ADDENDUM NO. 2

PROJECT NO. 56-16-04  
ELMORE MAINTENANCE BUILDING HVAC ROOFTOP REPLACEMENT  
MILEPOST 79.9, EASTBOUND  
OTTAWA COUNTY, OHIO

**OHIO TURNPIKE AND INFRASTRUCTURE COMMISSION  
ADDENDUM NO. 2  
PROJECT NO. 56-16-04**

**OHIO TURNPIKE AND  
INFRASTRUCTURE COMMISSION**  
ARCHITECTURAL PLANS A-101

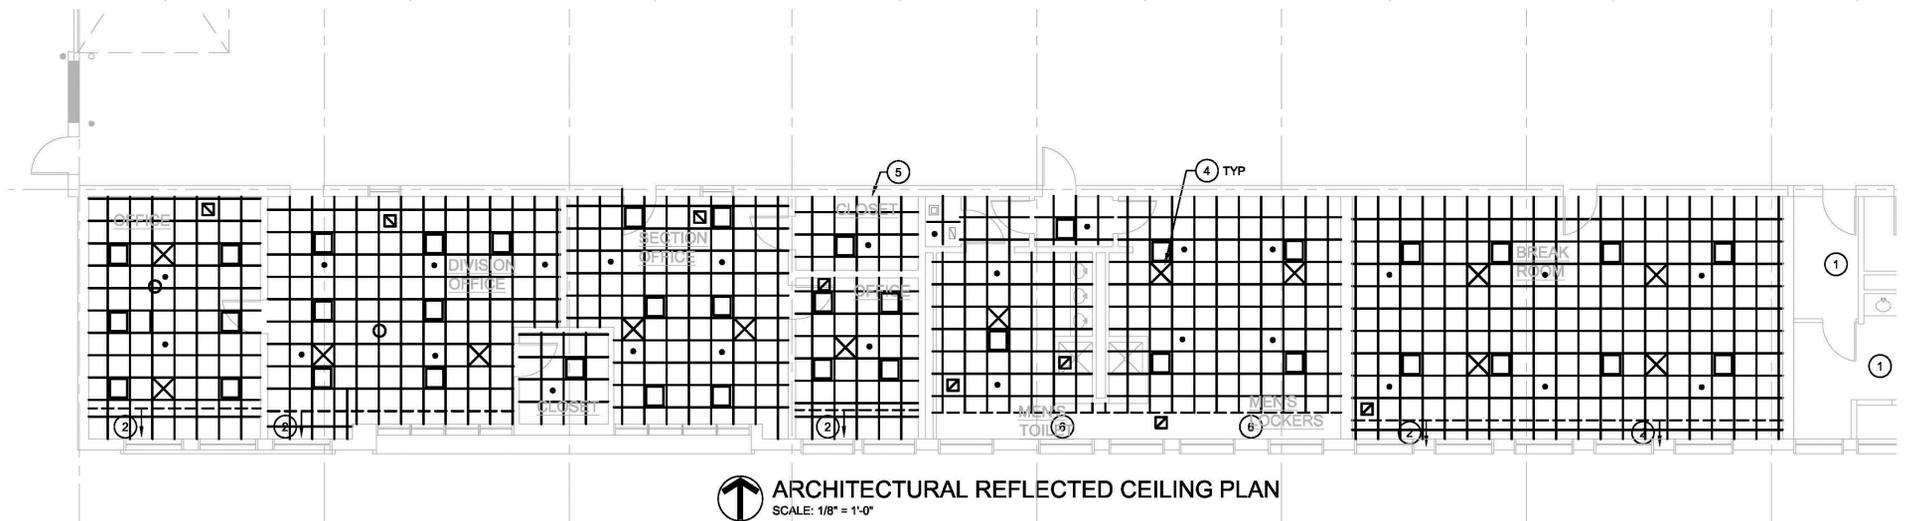
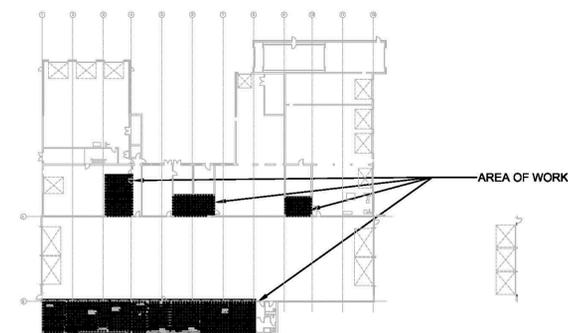
**The incorrect Plan Sheet - pertaining to a different Commission facility (Hiram Maintenance Building) - was attached to Addendum No. 1. With this Addendum No. 2, the Commission substitutes the attached correct Plan Sheet 2 of 8 pertaining to the Elmore Maintenance Building under Project No. 56-16-04 containing the same new General Note as follows:**

"8. DEMOLITION OF EXISTING DRYWALL CEILING IN THE MENS TOILET AND LOCKER ROOM  
SHALL BE PERFORMED BY THE CONTRACTOR."

Revised Plan Sheet 2 of 8 attached to Addendum No. 1 is rescinded in its entirety and wholly replaced and superseded by the attached revised Plan Sheet 2 of 8 for Project No. 56-16-04 via this Addendum No. 2 and incorporated by reference into the Contract Documents.

8. DEMOLITION OF EXISTING DRYWALL CEILING IN MENS TOILET AND LOCKER ROOM SHALL BE PERFORMED BY THE CONTRACTOR.
